Project: 90009590 - I-405 - Brickyard to SR527  
 Bothell, Washington 98011

## BY-CRE-03798\_009727\_RFI\_00627\_16.03.02\_BRT Below Grade Waterproofing Revisions Missed Prior to RFC

Washington State Department of Transportation  I-405, Brickyard to SR 527 Improvement Project Contract No. 009727	Doc Type: RFI
		REV#: 0
		SPEC SECTION:
		DATE: 10/22/2025
		CRE #: BY-CRE-03798

DRAWING NO.:  
**BT230-AVX150**  
 FACILITY ID:  
 BT230  
 SHEET No.:  
 REV:  
 0

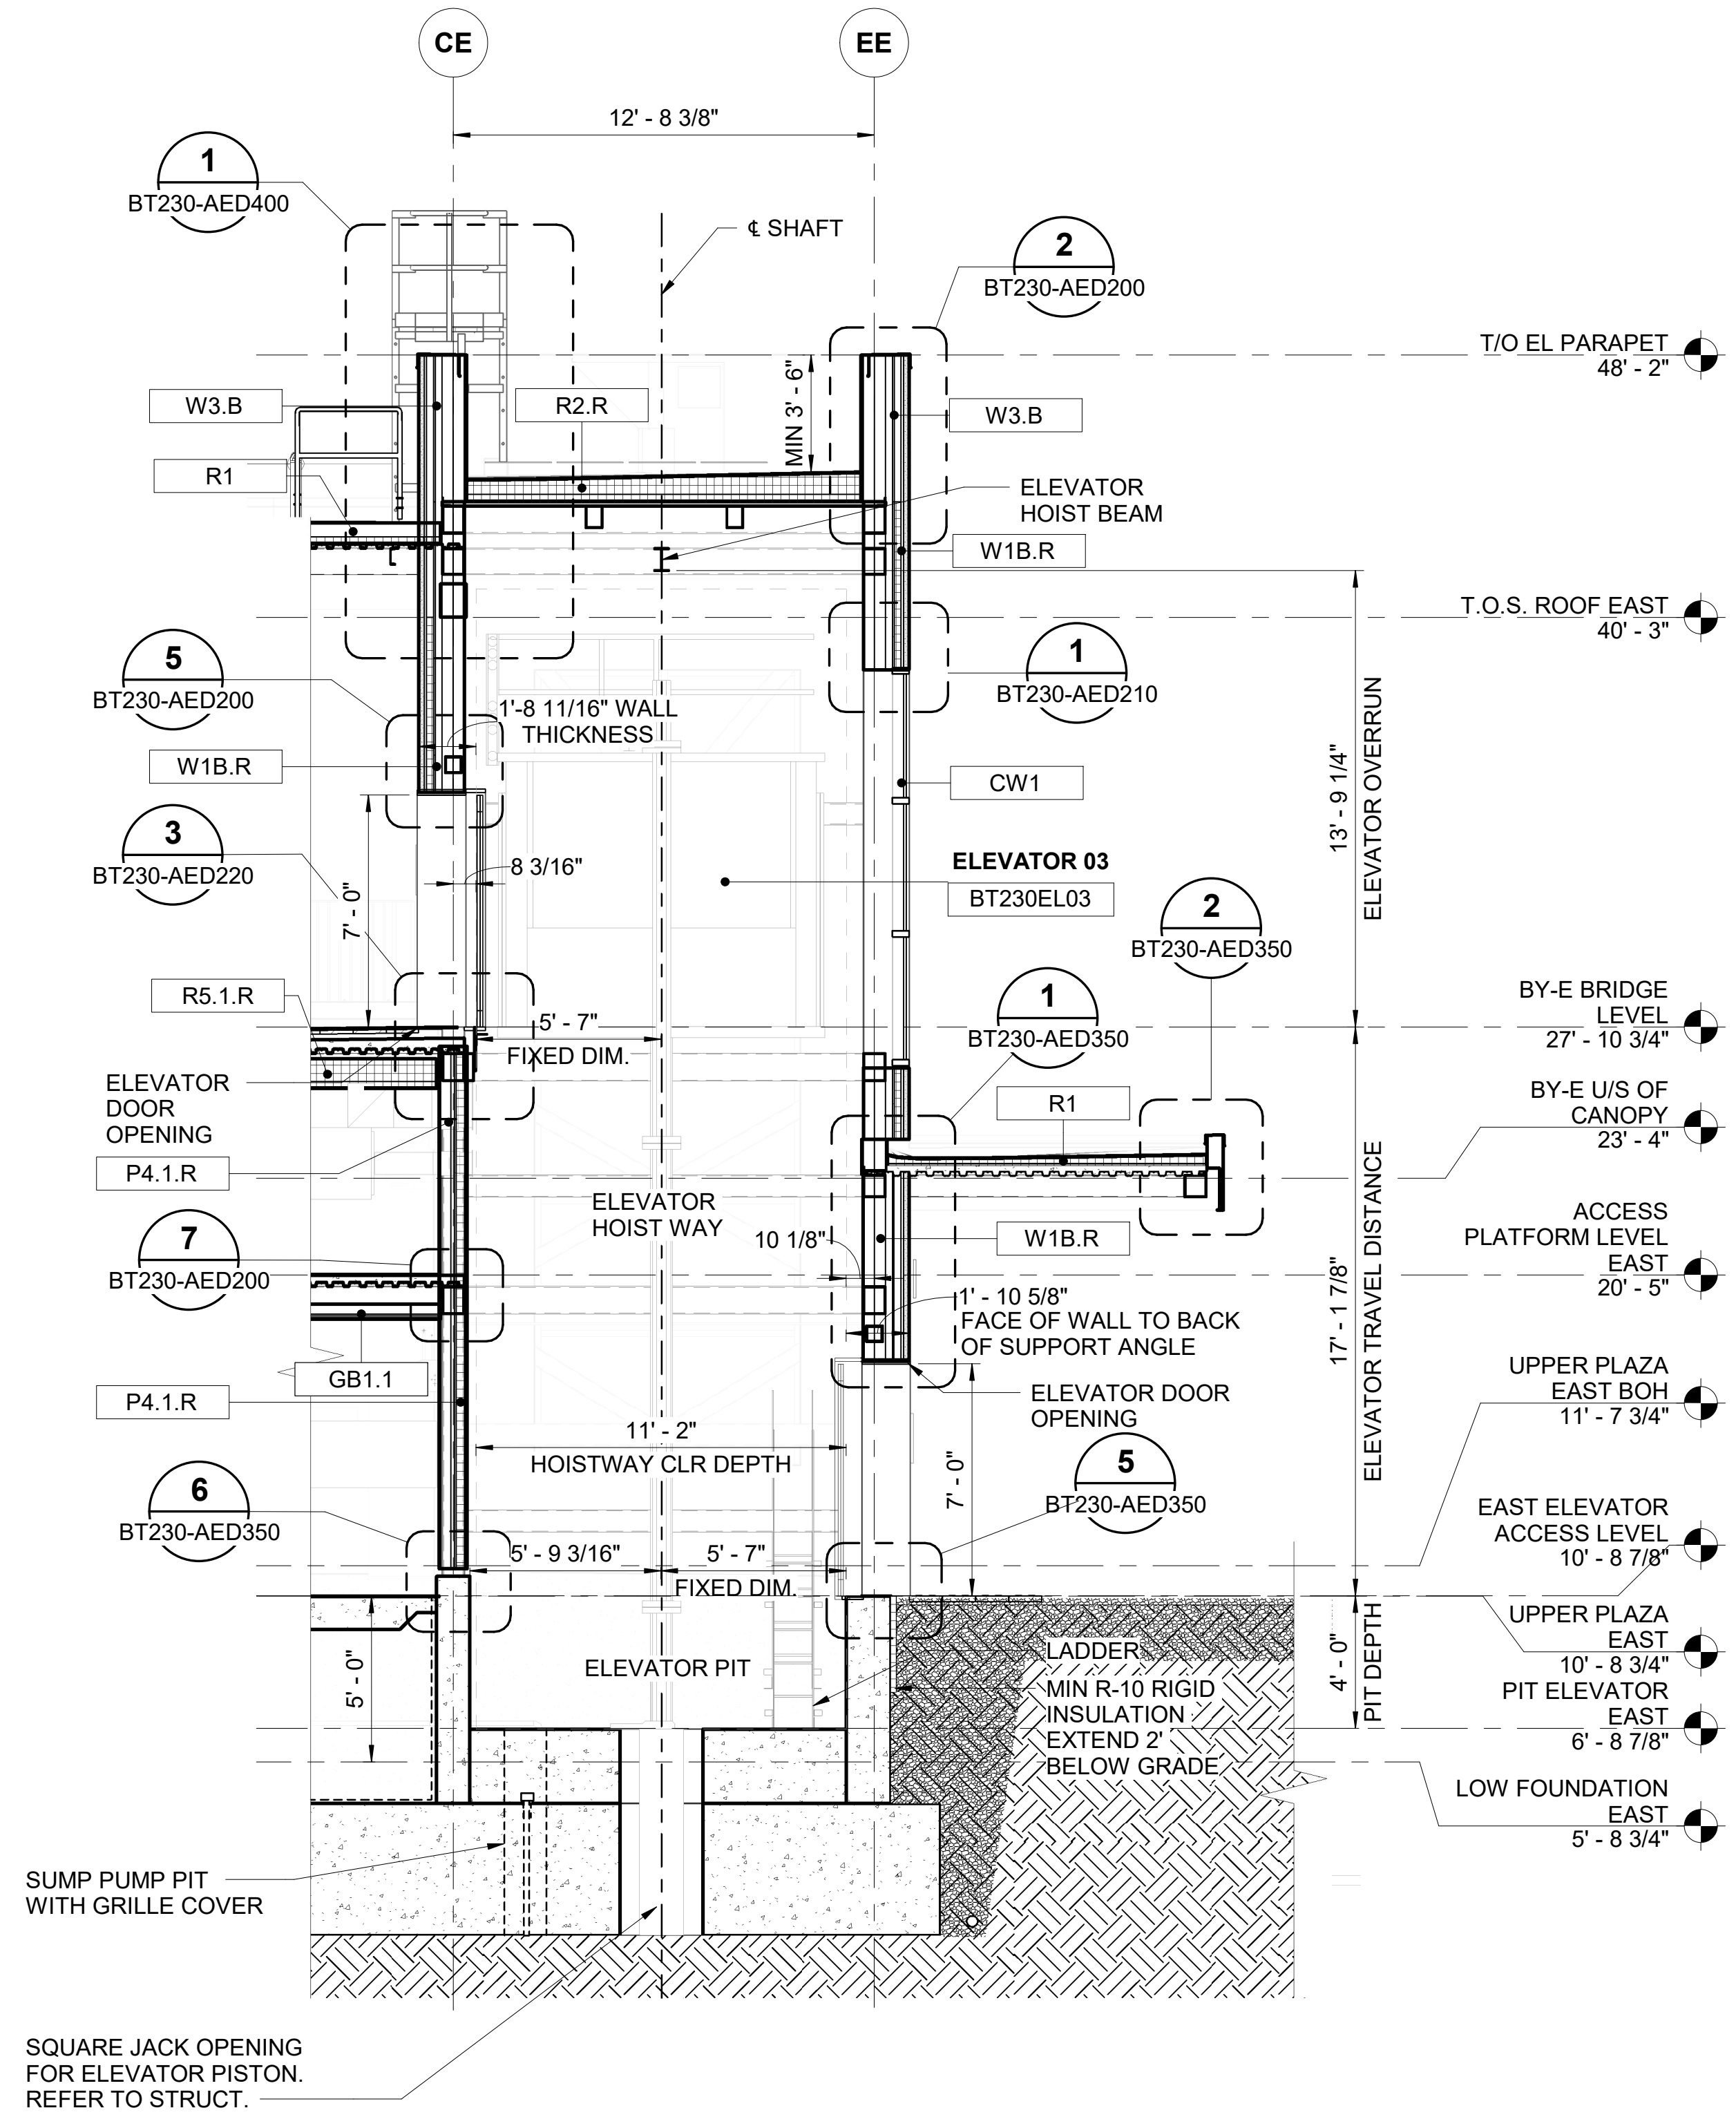
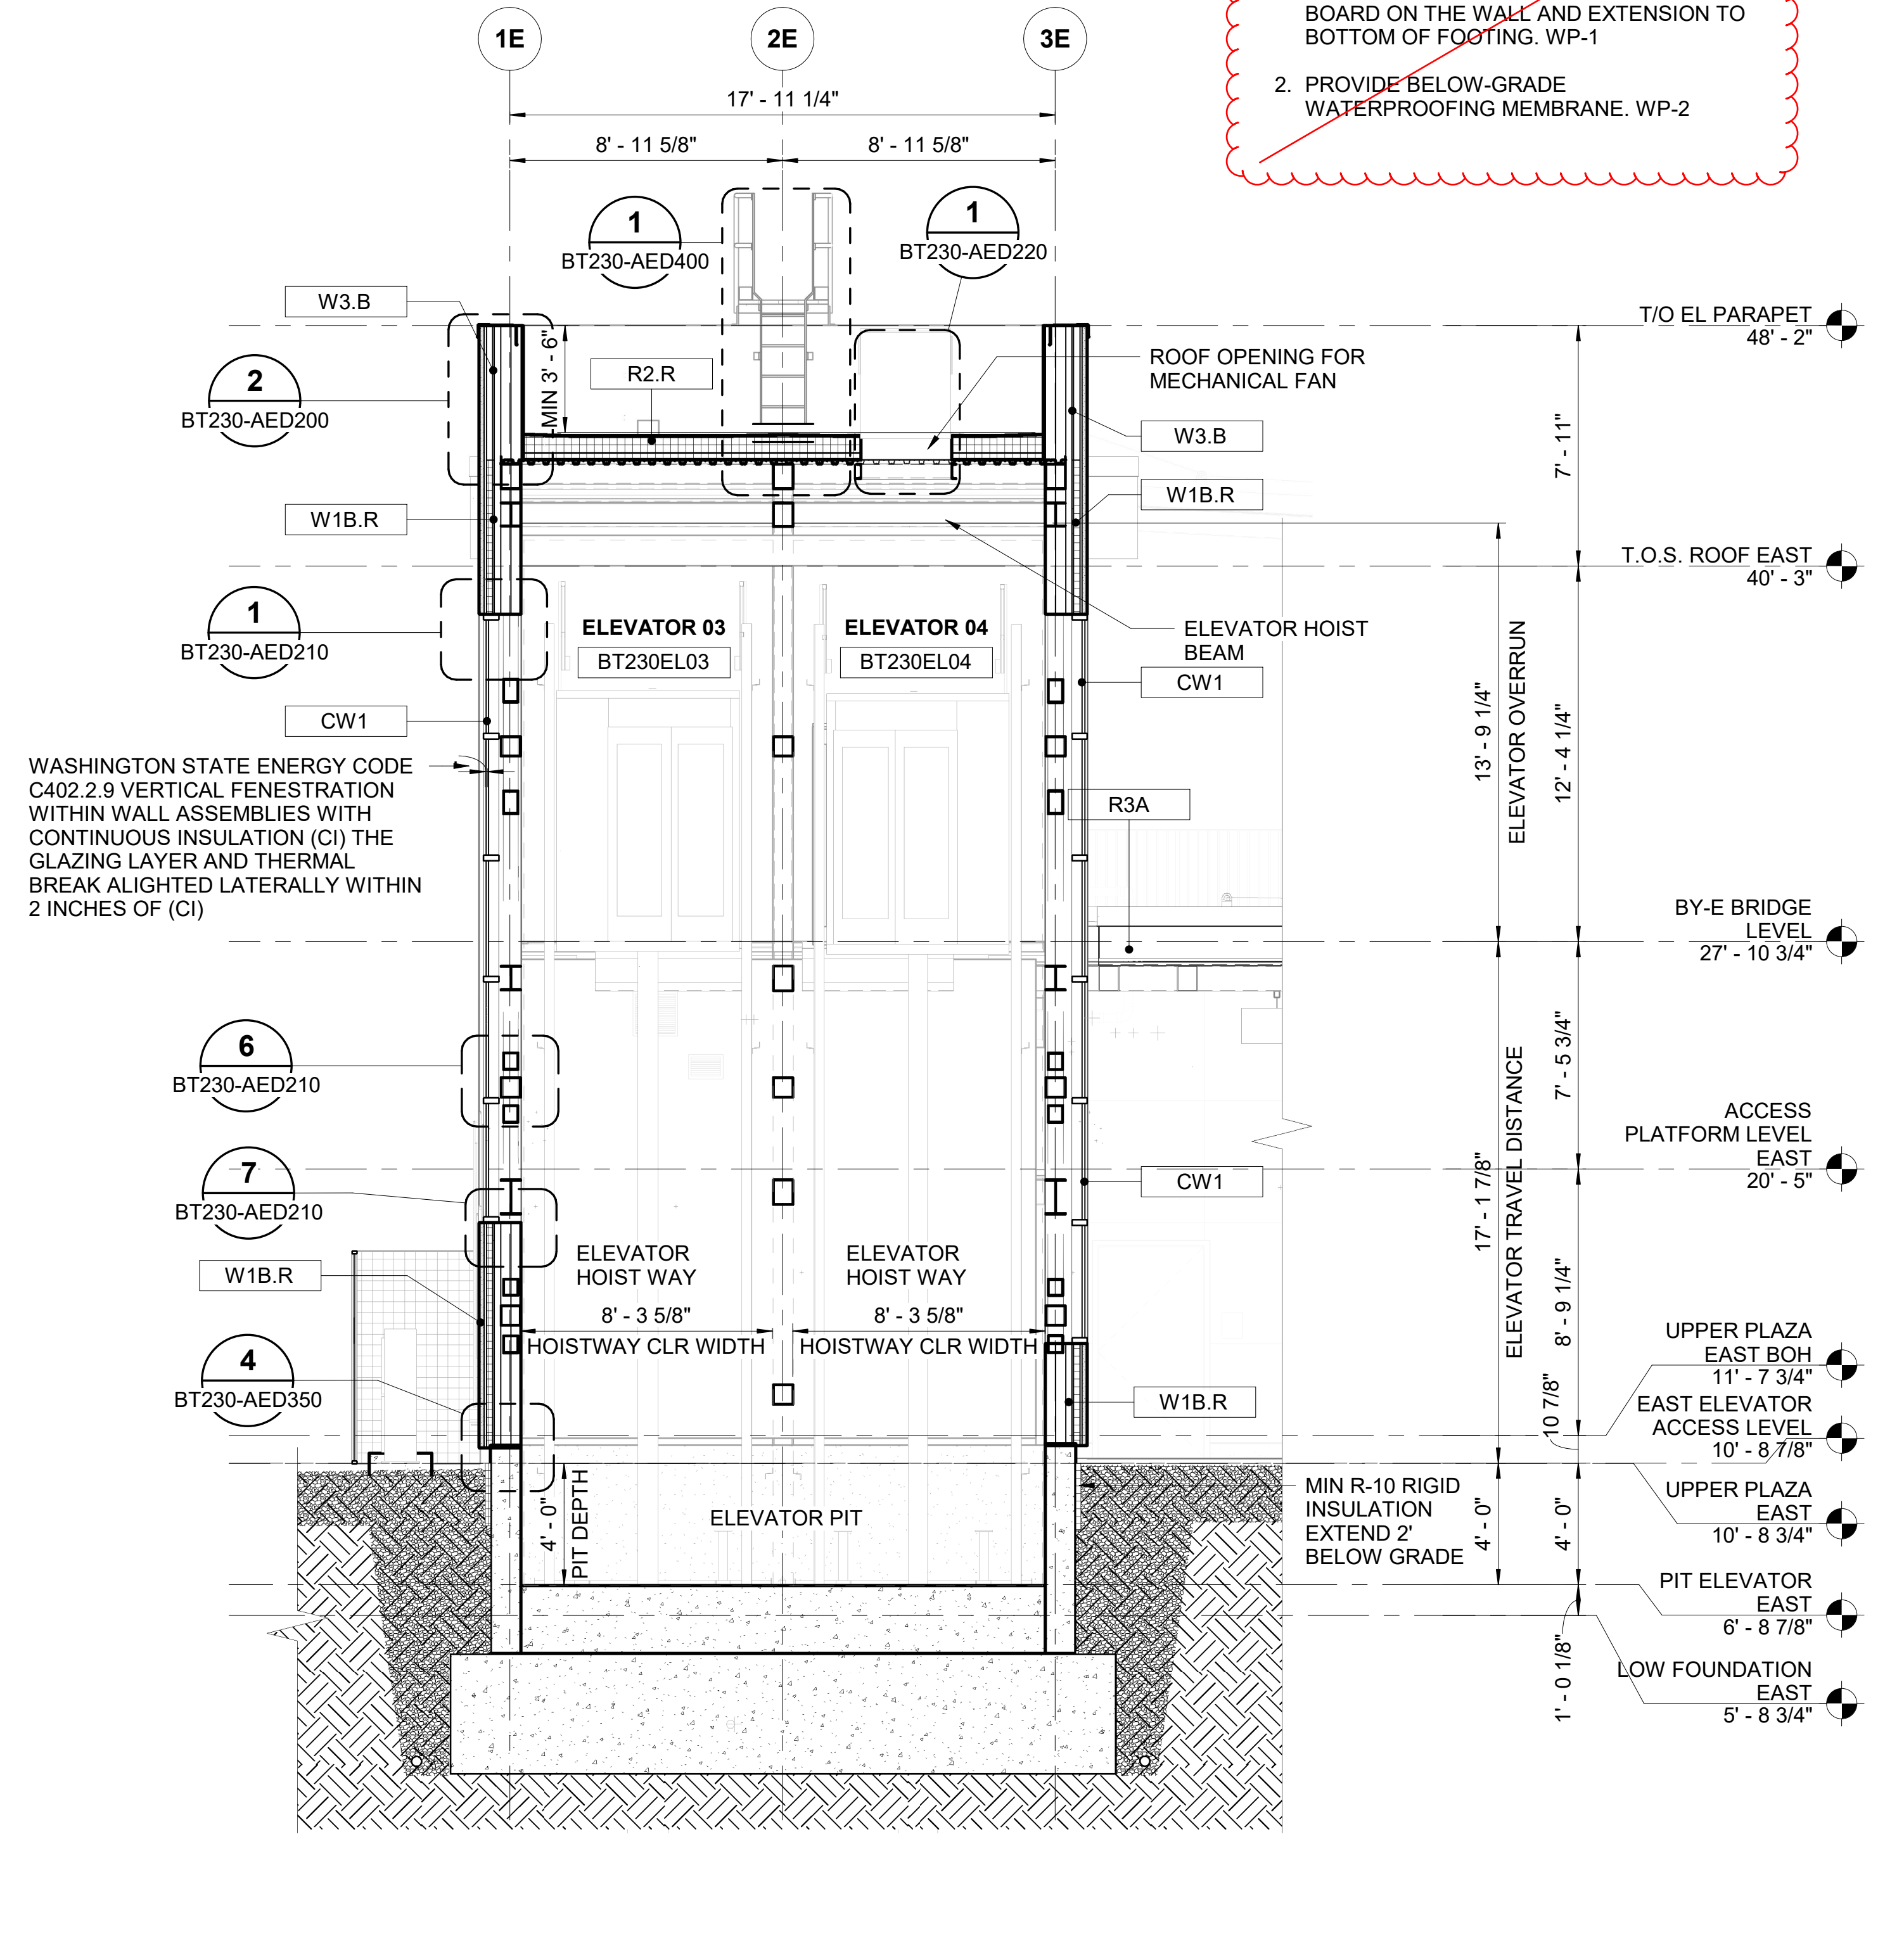
Q. AECOM please confirm all below grade waterproofing that has been marked on the attached drawings should have been removed prior to RFC.

**AECOM response:** Yes, waterproofing should be removed in marked up areas to be consistent with section AVX150 and AEX series where the waterproofing was omitted.

Please note the rigid insulation R-10 still should be extended 2' below grade as indicated.
